Oregon Department of Geology & Mineral Industries  
800 NE Oregon St, Suite 965  
Portland, OR 97232

## OLC Panther Creek 2015 Lidar Project Lidar QC Report – March 29<sup>th</sup>, 2016

**Figure 6. Example of missing ground in lidar bare earth data. Ground is clearly visible in highest hit model, but has been removed from the bare earth model. This type of classification error is common near water body features**

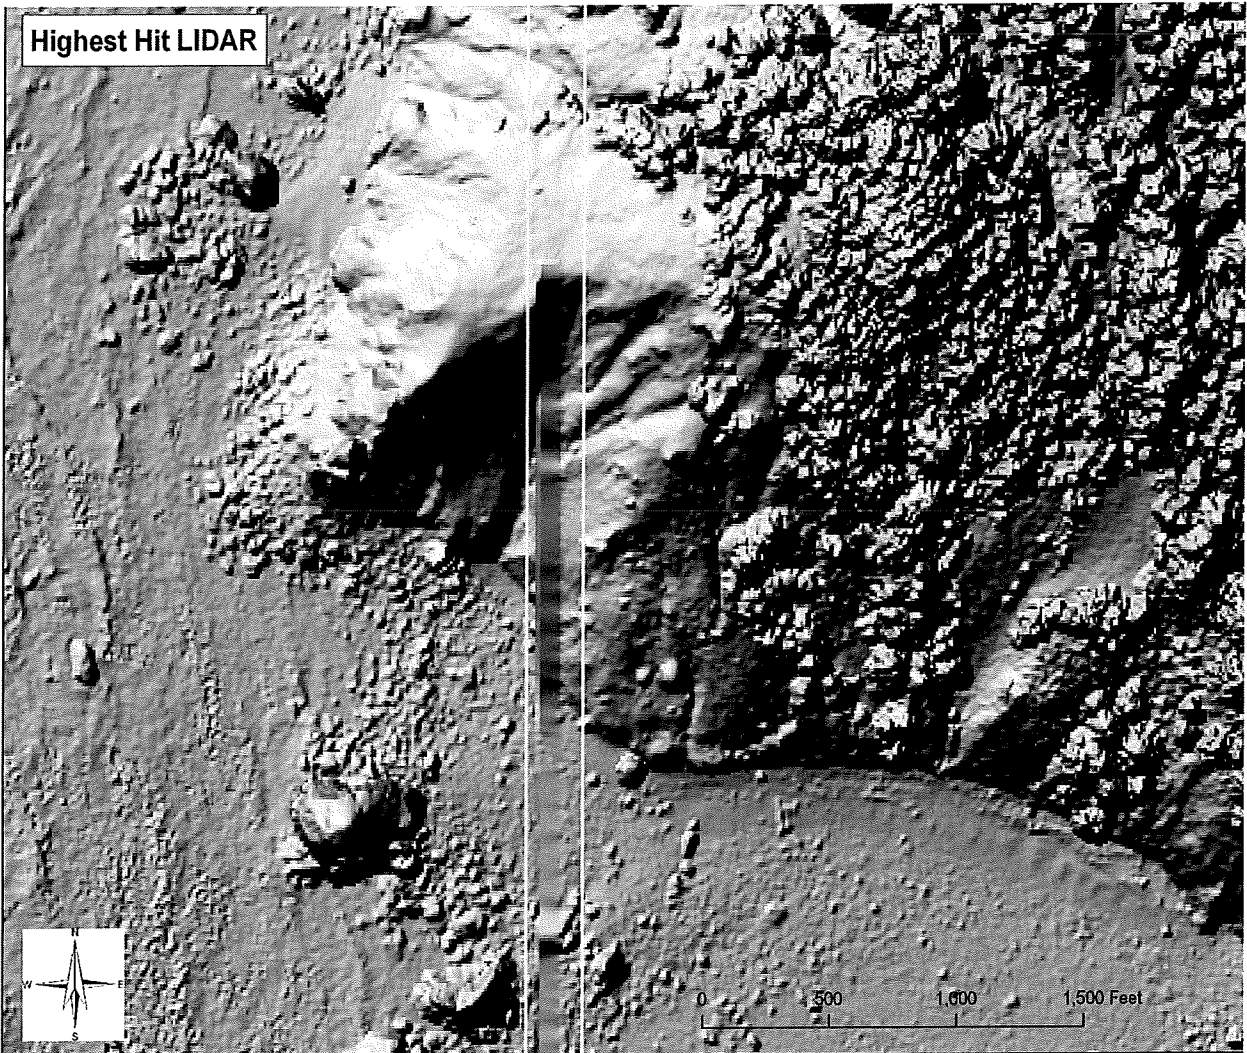
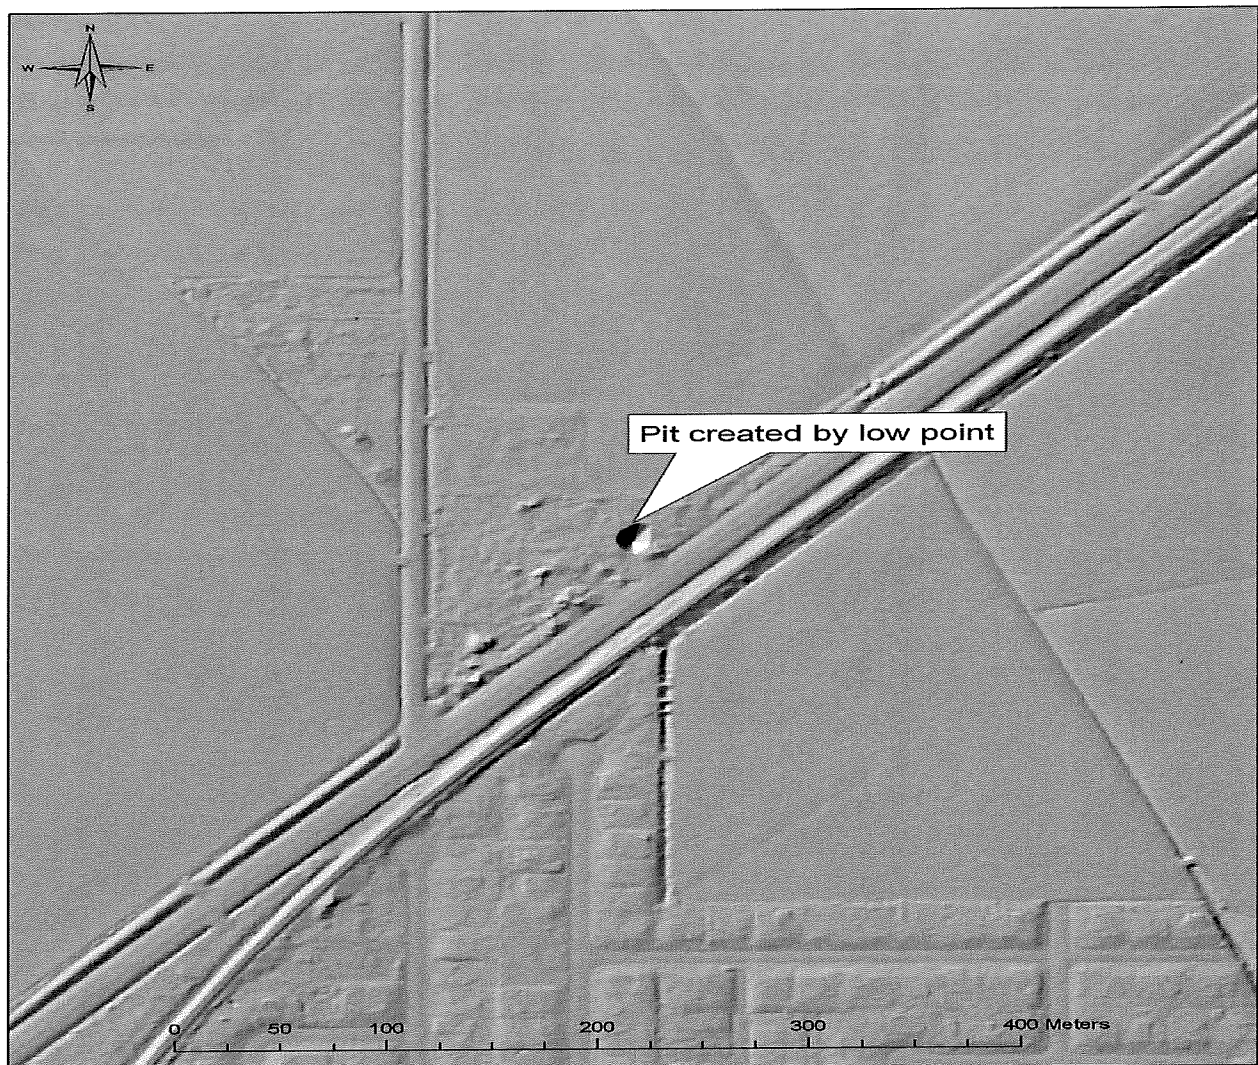
Lidar 3ft grids were loaded into ArcGIS™ software for visual analysis. Data were examined through slope and hillshade models of bare-earth returns. Hillshades of the highest hit models were used to identify areas of missing ground (Figure 6). Both bare-earth and highest hit rasters were examined for calibration offsets, tiling artifacts (Figure 7), seam line offsets, pits (Figure 8), and birds.

Calibration offsets typically are visualized as a corduroy-like pattern within a hillshaded lidar model. These offsets present themselves along steep slopes and typically stand out more in highest hit models than bare earth. Tiling artifacts are a result of missing or misclassified data along the edge of lidar processing tiles. These artifacts present themselves as linear features typically 1-2 grid cells in width, and are present in both the highest hit and bare earth models (Figure 7). Seam line offsets occur where two distinct days of lidar data overlap. Errors occur as a result of improper absolute vertical error adjustments. These errors are typically visualized as a linear stair step running along the edge of connecting flight lines. Pits and birds refer to uncommonly high or low points that are the result of atmospheric and sensor noise. Pits (low points) typically occur where the laser comes

in contact with water on the ground (Figure 8). Birds (high points) typically occur where the laser comes into contact with atmospherics<sup>1</sup>.

Figure 9. Spatial distribution of visual QC errors located by DOGAMI staff.

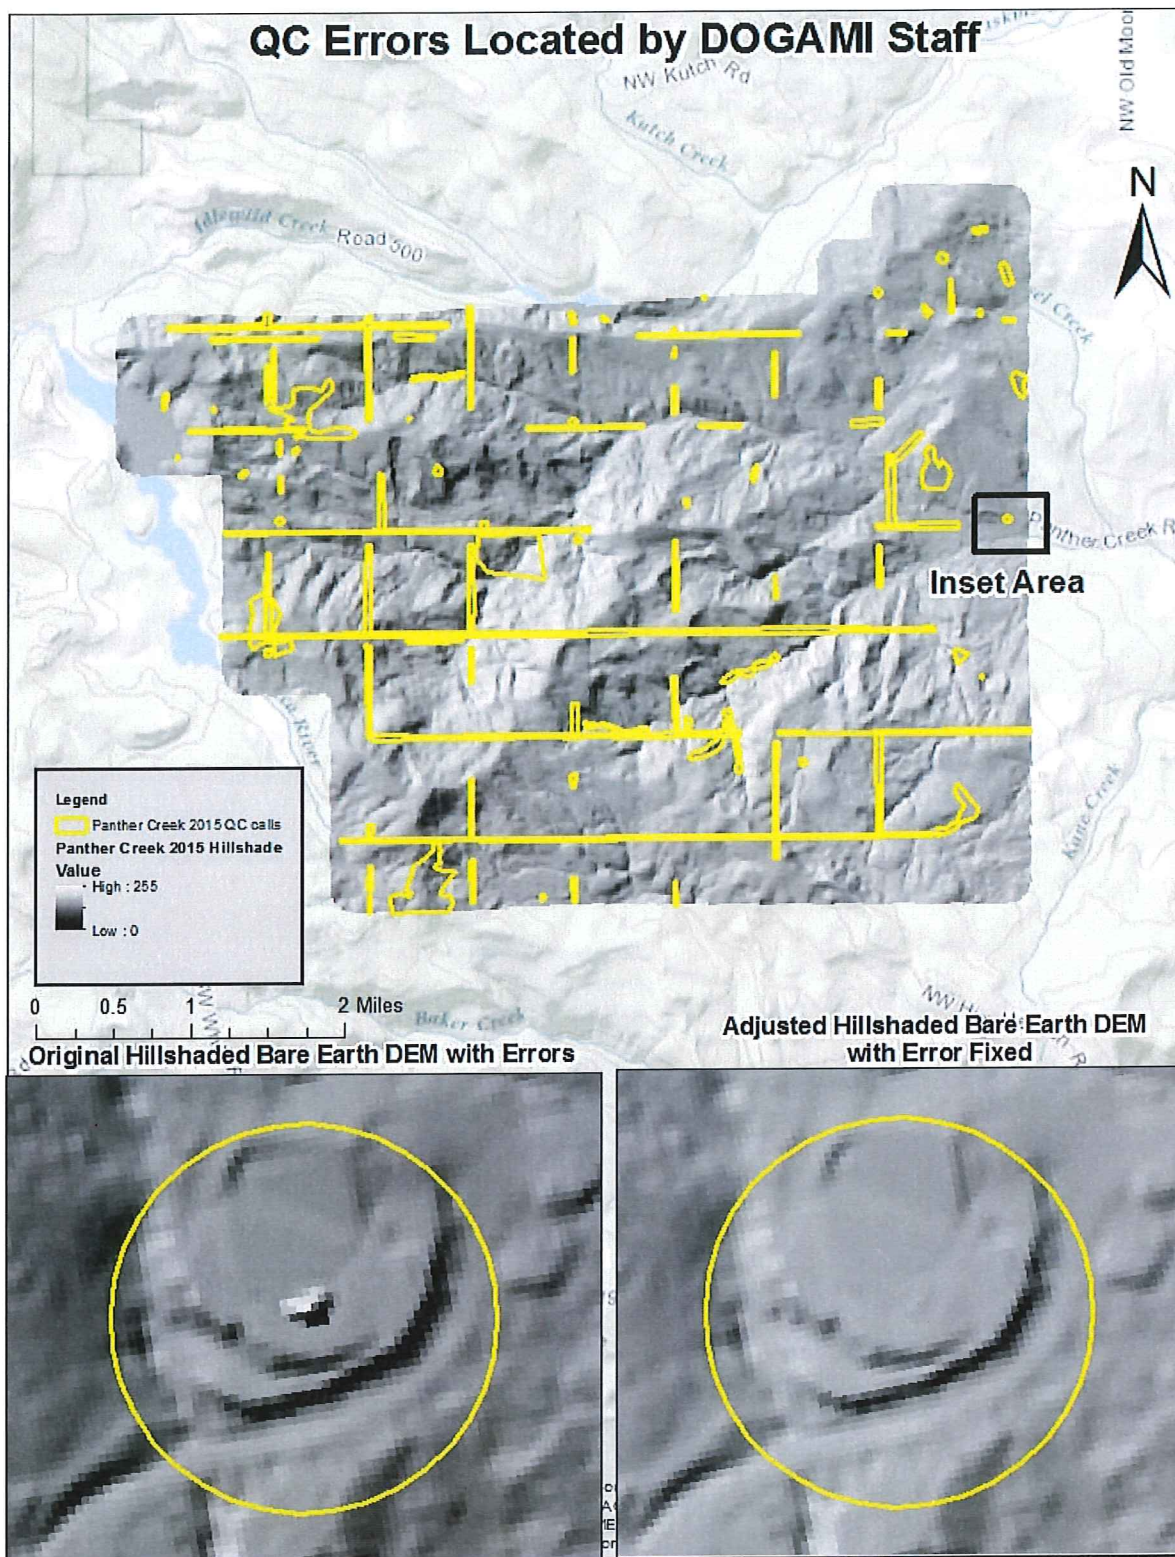
During visual analysis of Panther Creek 2015 raster data, 97 observed errors were digitized for spatial reference and stored in Esri™ shapefile format. Each feature was assigned an ID value and included a brief description of the observed error. The shapefile was then delivered to the vendor for locating and fixing errors. Upon receiving the observed error locations, the vendor performed an analysis to conclude whether the error was valid and provided comments on how the data was adjusted. 97 out of the 97 observed errors (100%) were adjusted and the data was reprocessed to accommodate fixes. Some of the reported errors by DOGAMI staff were not fixed by the vendor because either there was not enough data to improve the DEM or the QC call was not valid (call to remove bridge points from ground when the feature was actually a culvert). Errors that were not fixed by the vendor were reviewed by DOGAMI staff to ensure justification was valid. Final sets of lidar 3 ft grids were loaded into ArcGIS™ software and examined to ensure edits were made and visually inspected an additional time for completeness (Figure 9).
